37/03-07V 26 PINE AVENUE  
TAKOMA PARK HISTORIC DISTRICT

SUBJECT: Historic Area Work Permit #457272, rear addition and alterations

The applicant is proposing two changes to what was previously seen and approved by the HPC. These changes are as follows:

**MONTGOMERY COUNTY HISTORIC PRESERVATION COMMISSION**  
**STAFF REPORT**

*NEW PROPOSAL*

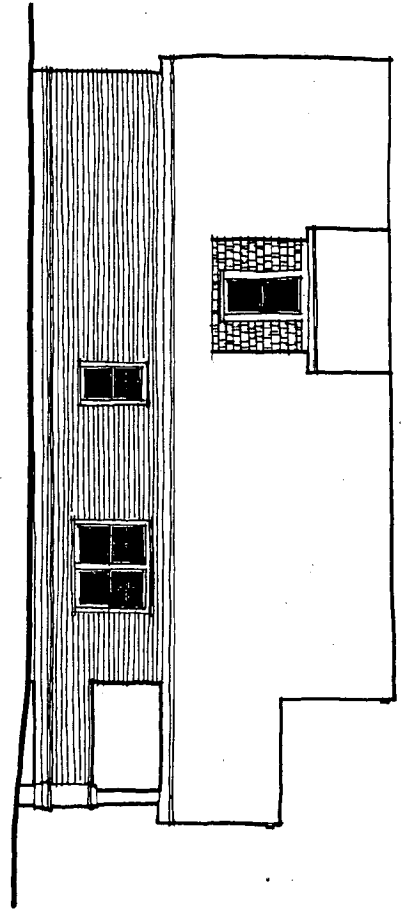
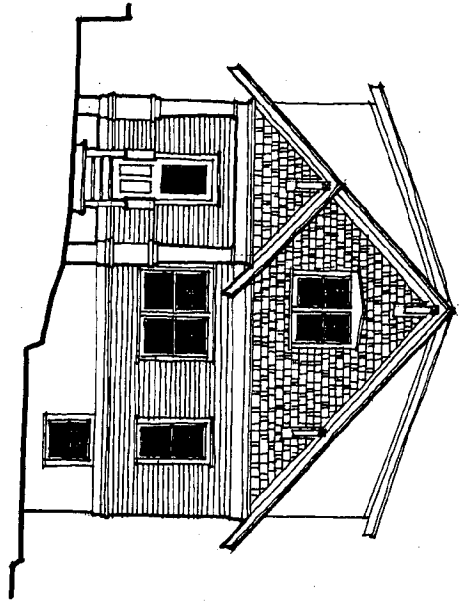
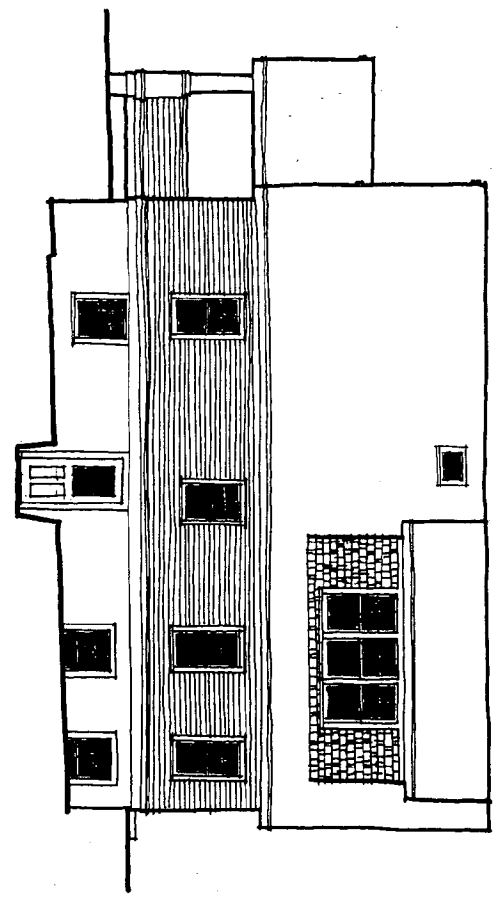
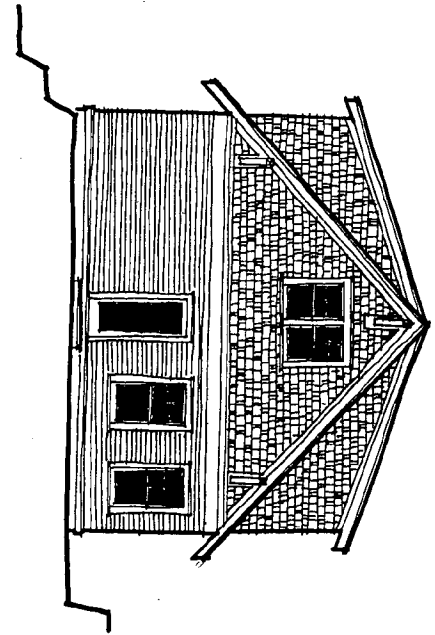
1. The applicant would like to move both roof dormers forward 3'0" to accommodate a readjustment to the interior space of the subject property. The style, pitch and proportion of both dormers facing the public right-of-way will remain the same as what was previously approved by the HPC. One slight modification to the dormer on the left elevation will include the installation of one 4/1 wooden window instead of the previously approved two 4/1 wooden windows. (See attached plans).

2. The applicant would also like to simplify the design of the partial 2<sup>nd</sup> -story addition on the rear elevation of the house. The original proposal included an 18" projection beyond the footprint of the existing 1<sup>st</sup> floor section of the house. The revised plan indicates the partial 2<sup>nd</sup> -story addition at the rear will be flush with the existing 1<sup>st</sup> floor section of the house. The new proposal also aims to simplify the detailing on the house by removing several brackets on the rear elevation. (See attached plans).

If the HPC agrees with these proposed changes, staff will approve it.

— Staff Approve

1 FRONT ELEVATION  
Scale: 1/8" = 1'-0"

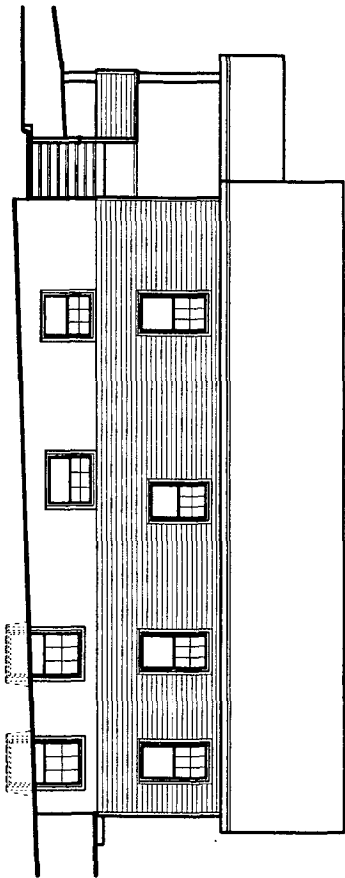
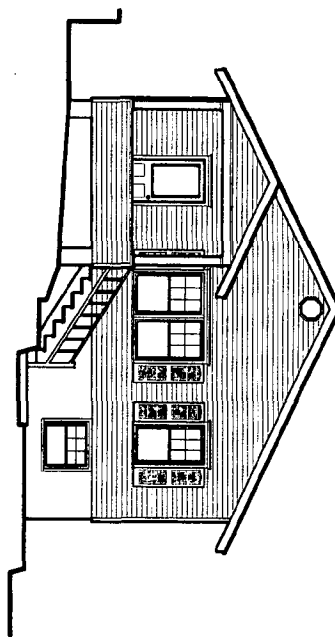
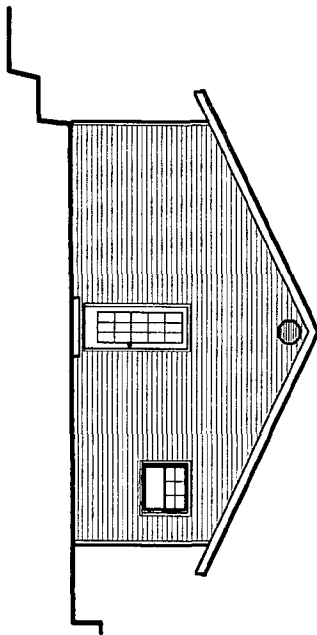
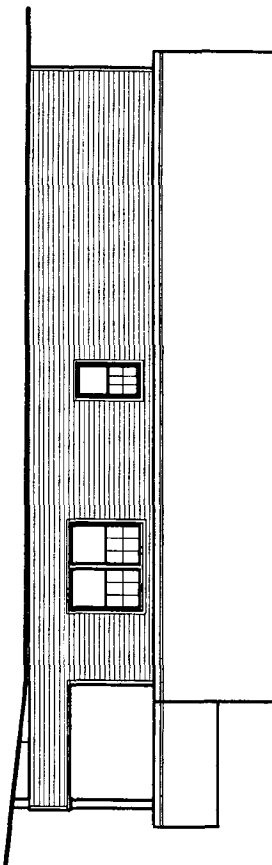
1. *The new front porch railings need to be true balustrades with inset pickets, and columns must be wood. (Detail to be shown on permit set of drawings).*
2. *The new windows and doors will be either true divided light (TDL) or simulated divided light (SDL) wooden windows. (Window schedule with specifications must be shown to staff prior to stamping final permit set of drawings).*
3. *The applicant will work with the Takoma Park arborist to determine if a tree protection plan is needed for this project. If required, the plan will be implemented prior to any work beginning on the property.*
4. *The new skylight must lie flat on the roof.*
